CITY OF ALBUQUERQUE

RE: **Lot 27 Block 8 S.A.D. 227 Unit 5**
6204 Marigold Ct. NW
Grading and Drainage Plan
Engineers Stamp Date 11/9/2021 (E10D112)

DRAINAGE AND TRANSPORTATION INFORMATION SHEET (REV 6/2018)

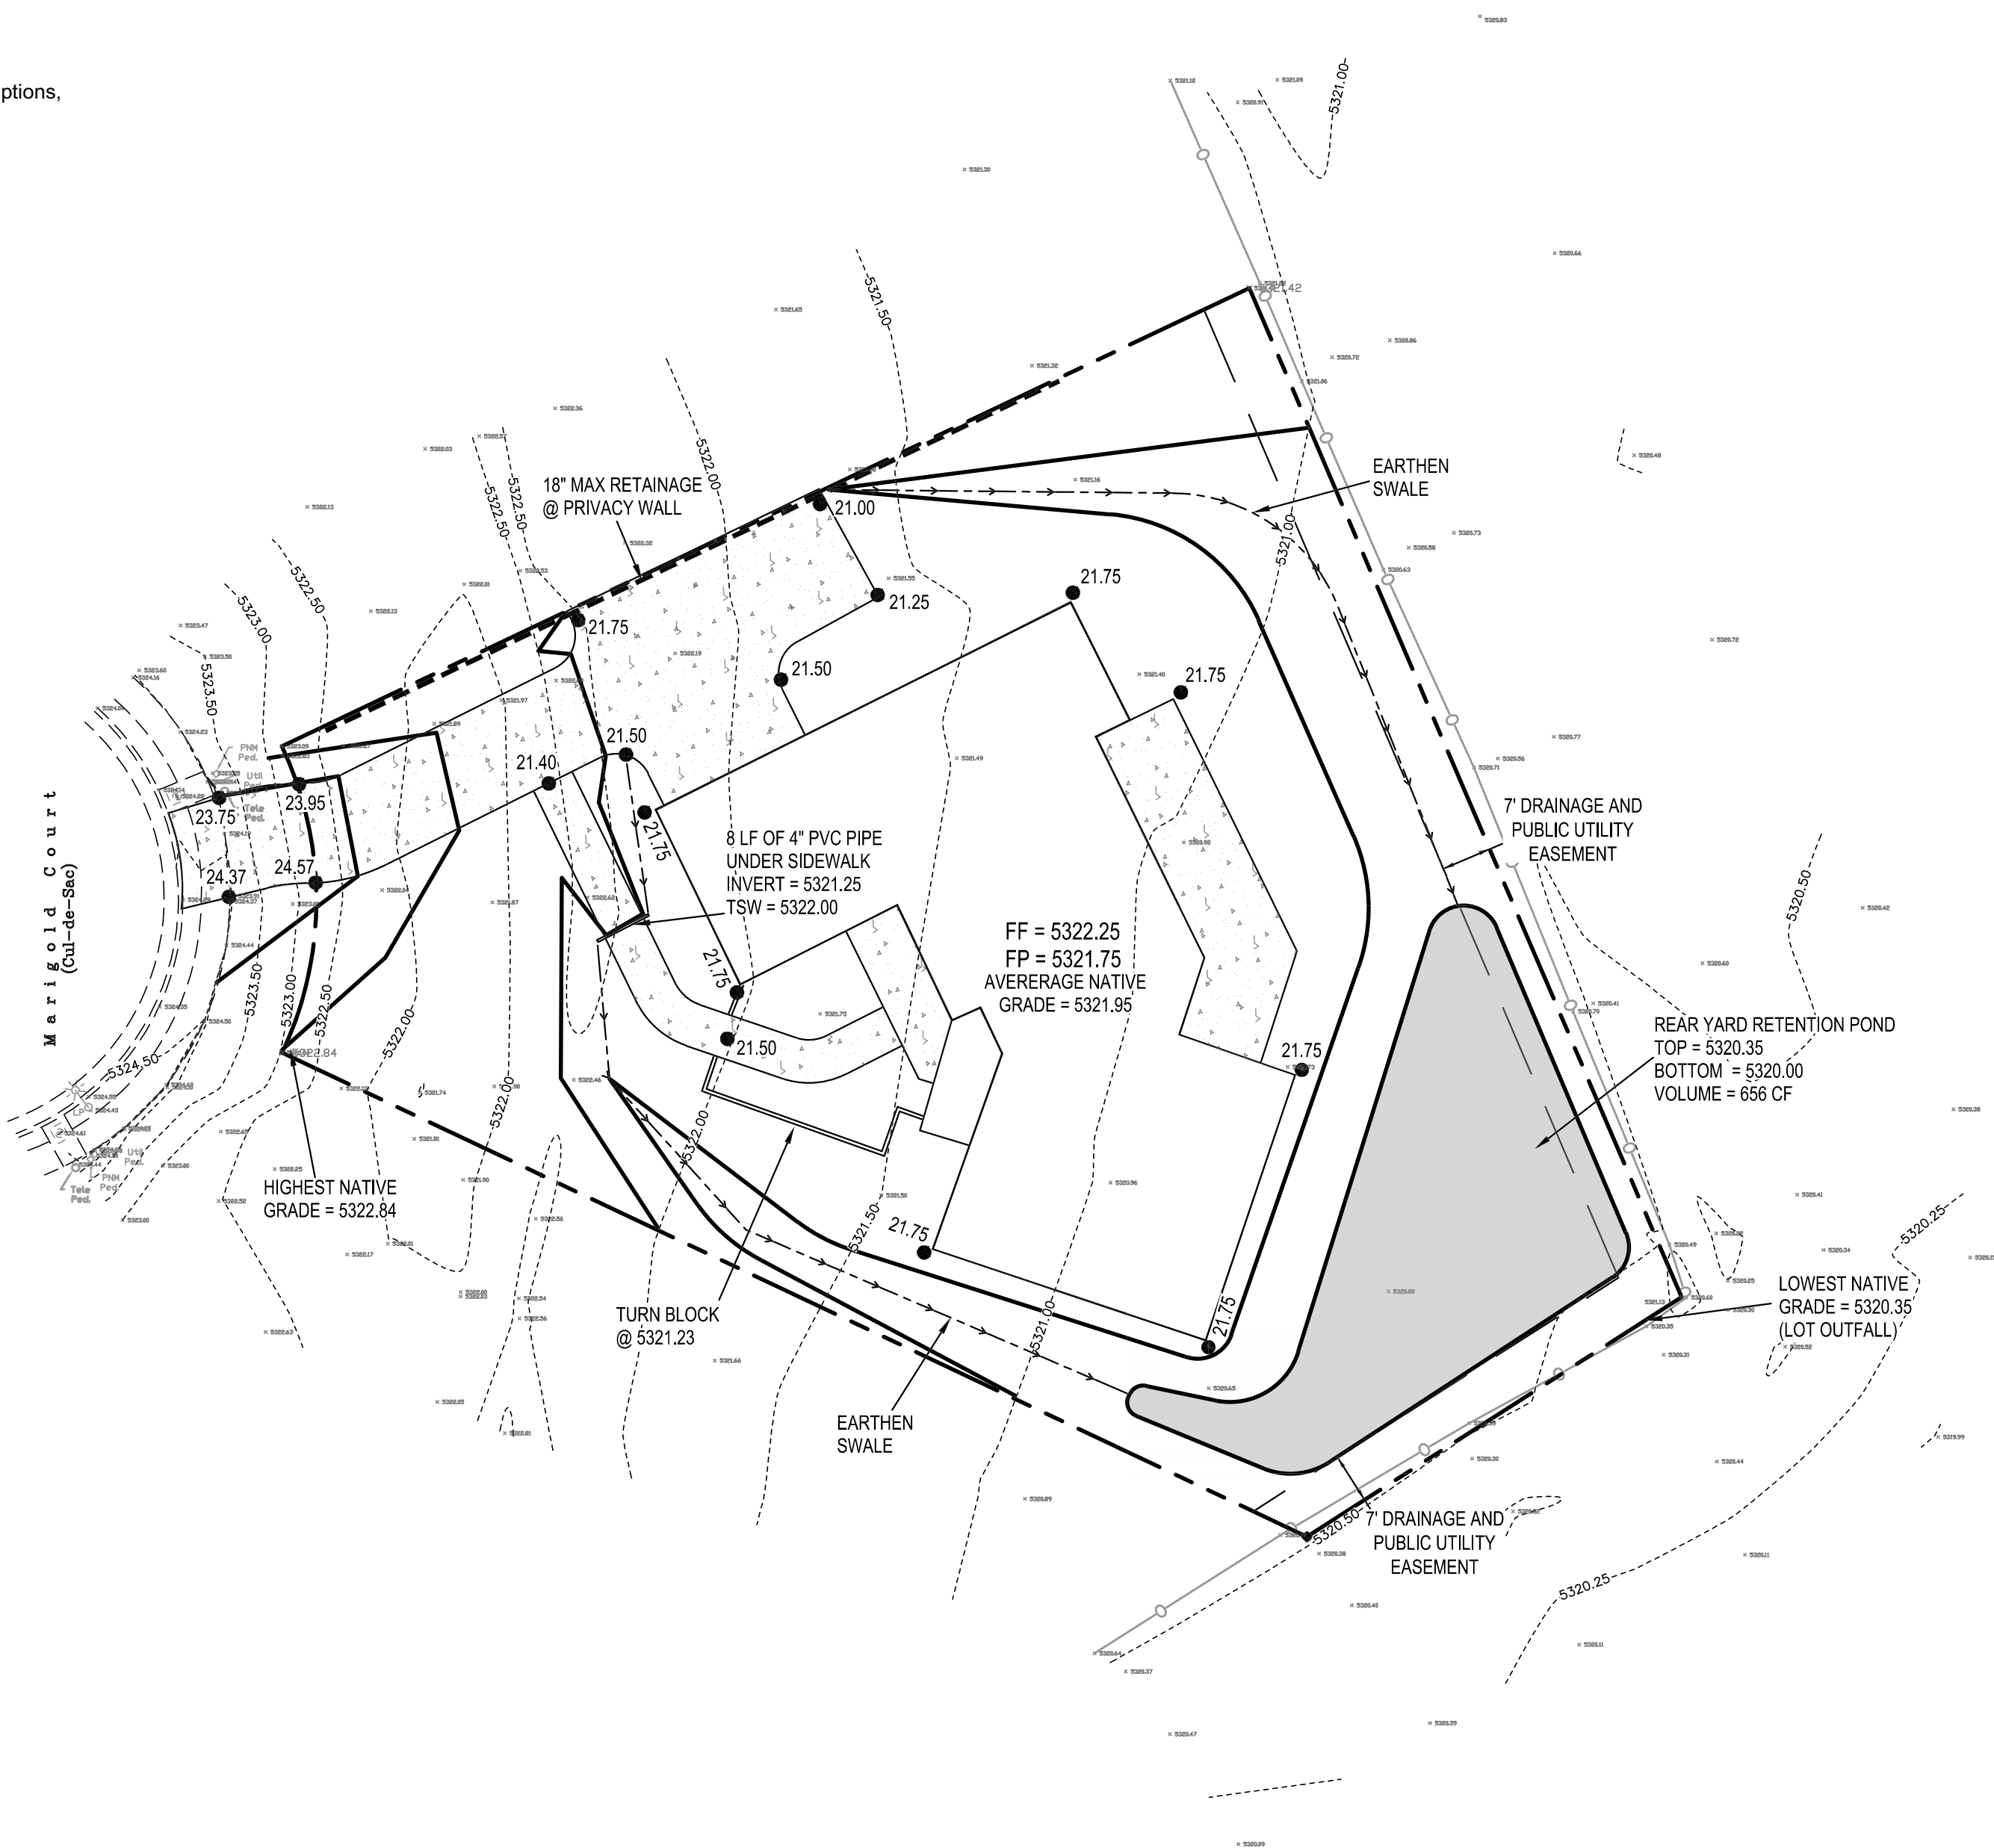
Based upon the information provided in your submittal received 11/9/2021, this plan is approved for Grading Permit. Please inform the builder/owner to attach a copy of this approved plan and letter into the construction sets in the permitting process prior to sign-off by Hydrology.

Reiterate to the Owner/Contractor that a separate permit for any garden/retaining wall must be obtained, with the approved G&D plan. Advise the owner contractor not to use dirt as a ramp to climb the curb, use lumber or crusher fines for this purpose. Also, let the owner/contractor know that if a pool is to be added in the future the G&D plan will need to be modified showing the location of the pool and the land treatment differences.

Prior to Building Permit approval, a **Pad Certification** will be required. Inform the contractor/owner not to pile dirt in the street as a ramp to climb the curb. If dirt is found in the street the pad cert. will be denied.

Prior to **Certificate of Occupancy release**, Engineer Certification per the DPM checklist of this plan will be required.
